Meeting Date: February 1, 2024	From: Abhinay Movva, Caltrans		
Sponsored By: Florencia Allenger,	Presented By: Abhinay Movva,		
Caltrans	Caltrans

Description: Proposed new traffic sign (R10-3k(CA)) for touch-free Accessible Pedestrian Signal (APS) with word message "PUSH OR WAVE AT BUTTON TO TURN ON WARNING LIGHTS." Revision to California Manual on Uniform Traffic Control Devices (CA MUTCD) Sections 2B.52, 4N.02, and 9B.11.

Attachment B – Proposed Revision to CA MUTCD Figure 2B-26 AND 9B-2.

Figure 2B-26. Pedestrian Signs and Plaques (Sheet 2 of 2)

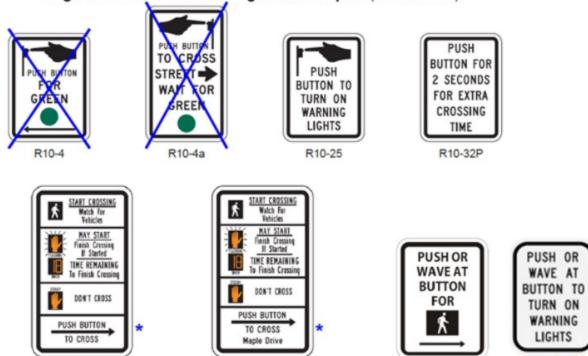
_{06d} The R10-3k(CA) sign may be used where Warning Lights or flashing beacons can be activated by pushing the button or waving at the button.

Modify Figure 2B-26 and 9B-2 as shown:

R10-3k(CA)

Figure 9B-2. Regulatory Signs and Plaques for Bicycle Facilities

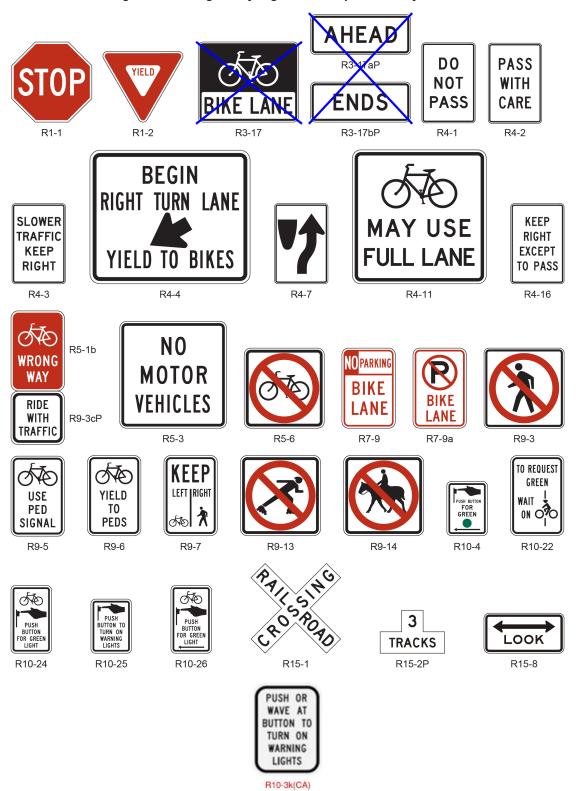
o4 If bicyclists are crossing a roadway where In-Roadway Warning Lights (see Section 4N.02) or other warning lights or beacons have been provided, the R10-25 sign or R10-3k(CA) sign (see Figure 9B-2) may be used.

R10-3k(CA)

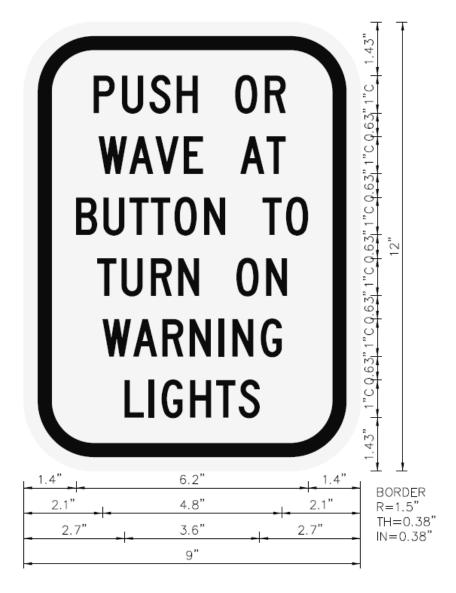
Proposal: Add Sign Specification R10-3k(CA).

COLORS: LEGEND – BLACK
BACKGROUND – WHITE(RETROREFLECTIVE)
